## Section 75W to Concept Plan (MP10\_0003)

### Discovery Point, Wolli Creek

Submitted to Department of Planning & Infrastructure  
On Behalf of Discovery Point Pty Ltd

March 2012 ■ 09642

Figure 4 – Updated building separation diagram for approval

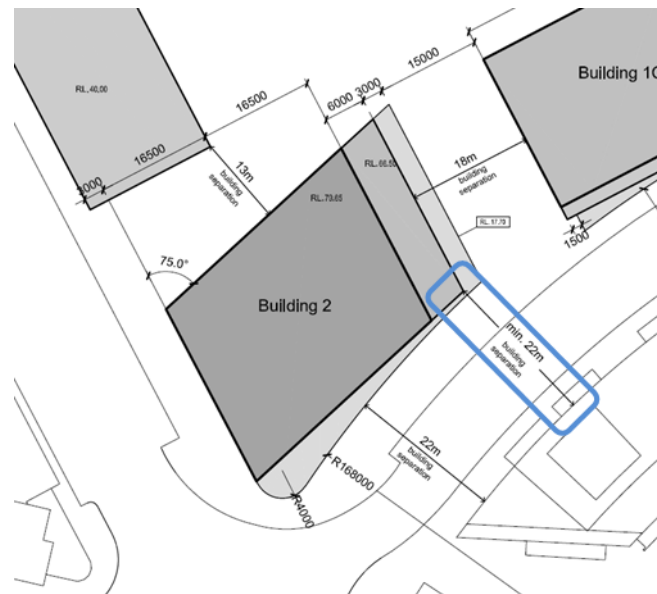
In the process of documenting the Stage 2 Development Application, it has become evident that there is a minor drafting error within the approved Concept Plan Proposed Building Envelopes drawing (DA3-001 Revision D dated 23/02/2011).

The drafting error relates to the position of the 22 metre building separation arrow between Building 2 and the existing building Verge (refer to **Figure 2**). The dimension arrow on the approved drawing is to the balcony edge. The dimension arrow in this case should carry beyond the balcony to the facade. The original reason the 22 metre dimension was labelled on the Concept Plan drawing was to establish a building separation distance less than the Residential Flat Design Code (RFDC) 'Rule of Thumb' for Levels 9 and above only (which do not have balconies).

However the distance between Building 2 and Verge main facade varies from the RFDC 'Rule of Thumb', which require a 24 metre separation for level 9 and above (**Figure 3**). This was justified within the Concept Plan EAR and PPR. As Building 2 would be located at a minimum distance of 22 metres from level 9 – 11 of Verge, a 22 metre dimension arrow was intended to be placed between the main façade of Verge and Building 2 to depict this variation (**Table 1**).

A minor drafting error accordingly occurred in translating the 22 metre dimension arrow on the Building Envelopes drawing. To correct this error, it is requested that the accompanying revised Building Envelopes drawing (DA3-001 rev G - included at **Appendix A**) be added to the plan list at Condition A2 of MP10\_0003 and replace the previously approved version. **Figure 4** provides an extract of the corrected placement of the 22m dimension arrow between Building 2 and the main façade of Verge.
